### IN THE DRAWING

Inventor: MITSURU MAEDA ET AL.  
Appln. No.: 09/816,119 GAU: 2625  
Filed: March 26, 2001  
Confirmation No.:  
SHEET 3 of 8

Reply to Office Action  
Dated 3/29/04  
Replacement Sheet

FIG. 9

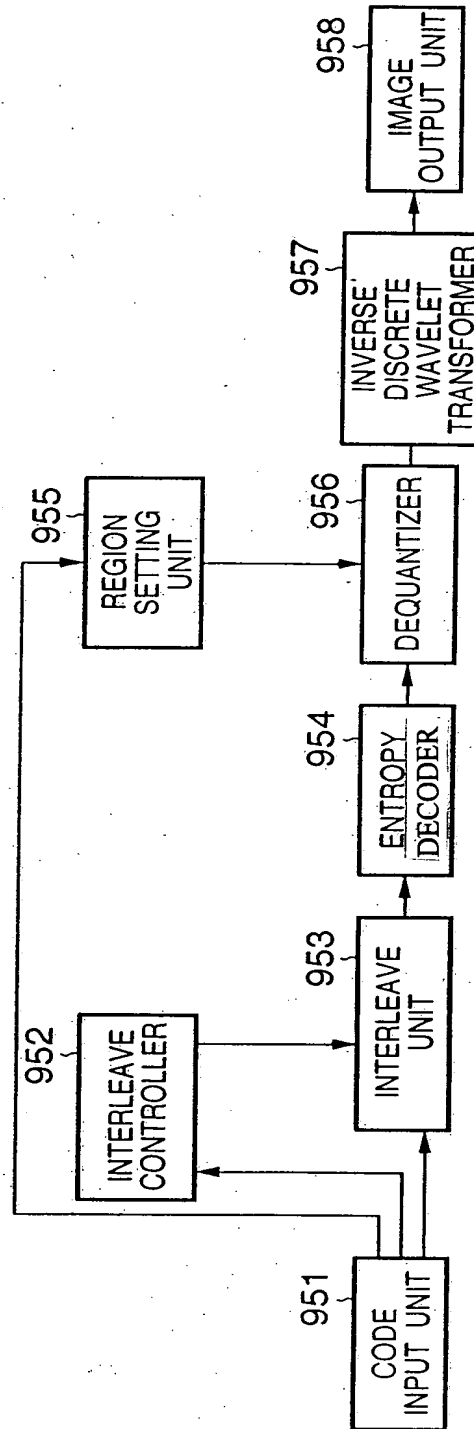
The attached sheets of drawings include changes to Figs. 9 and 12-18C. In particular, block 954 of Fig. 9 has been changed from “ENTROPY DECORDER” to --ENTROPY DECODER--. Furthermore, block 1004 of Fig. 12 has been changed from “ENTROPY ENCORDER” to --ENTROPY ENCODER--. Moreover, Figs. 12-18C have been labeled as --PRIOR ART--. The attached sheets of drawings replace the original sheets including Figs. 9 and 12-18C.
